Discretionary Review Full Analysis

HEARING DATE OCTOBER 20, 2016

Date:October 13, 2016Case No.:2015-001725DRPProject Address:2018 19th StreetPermit Application:2015.02.04.7444

AUGUST 2015 REAR ELEVATION: THIS IS THE LAST VERSION SEEN BY THE RDT

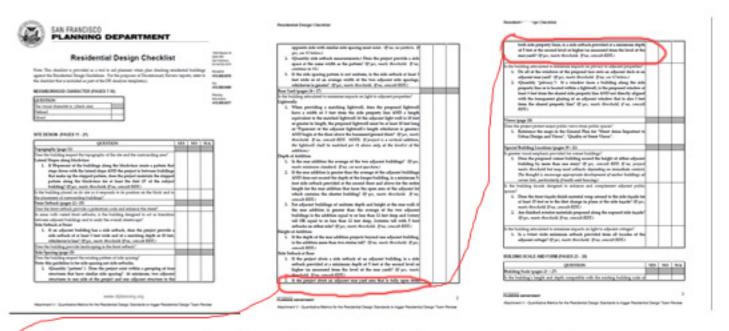
BUILDING WAS MADE LARGER IN THE DIRECTION OF MY PROPERTY AFTER IT LEFT RDT AND AFTER WE ASKED TO MEET WITH SPONSORS TO TALK ABOUT OUR CONCERNS.

Exhibit H

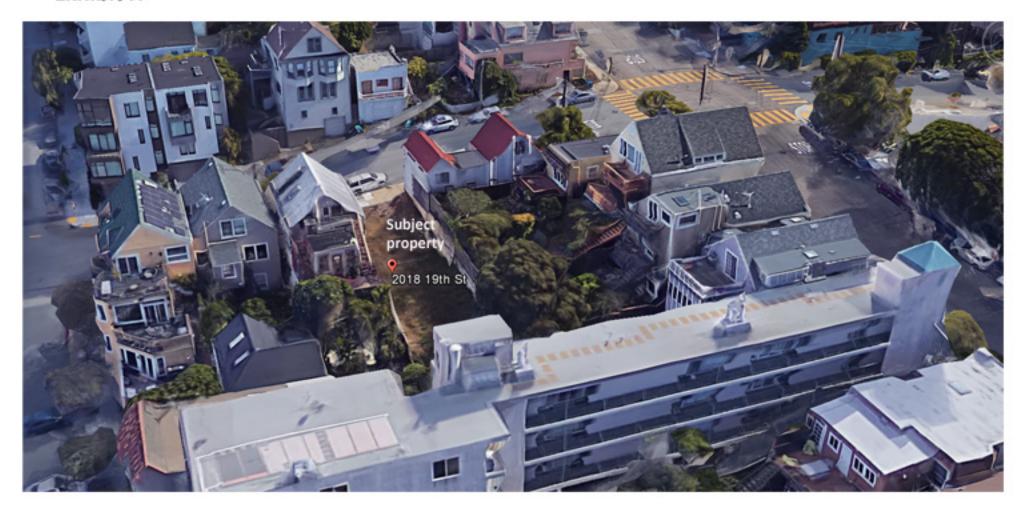
No Pattern of Roof Decks. Especially because the proposed building will be taller than all the others immediately surrounding it AND because it is a key lot overlooking four rear yards on Kansas Street it will have substantial negative impacts on privacy.

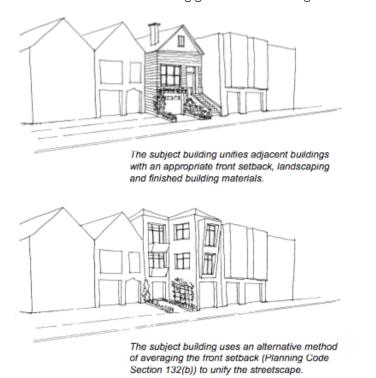
- Pull back the west wall by 3'-0". This was done only on the 3rd floor since the DR requester's property and property line fence are much higher than the ground floor of the new house so the top of the 2rd floor is only a few feet above the property line fence.
- Pull back the guardrails of the roof deck by 5'-0" from all building edges. This change reduced the deck size from 430 sq. ft. to 250 sq. ft.. The guardrails are designed to be of glass to visually reduce the mass of the building.

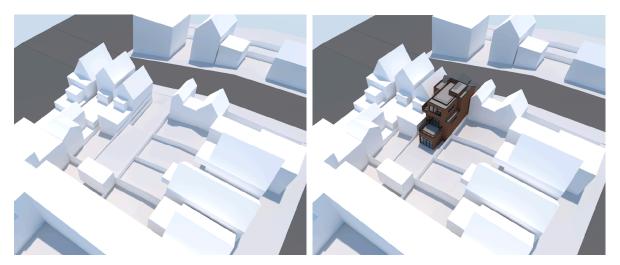
The DR requester is asking for an arbitrary setback (3') of the top floor with no identification of the extraordinary circumstance that this portion of the building would create. Any new building or object will of course, throw shadows throughout the day. But given the position of the DR requester, the only additional shadowing to the DR requester's yard occurs in the morning hours at the east end of her property. By late morning, the sun path in the southern sky pushes the shadow of the new house into the rear yard of the subject property and then into the northeast and then east. The bulk of the shadow that falls in the DR requester's yard already exists from the neighboring house to the south (2124 19th Street) and her own home to the west.
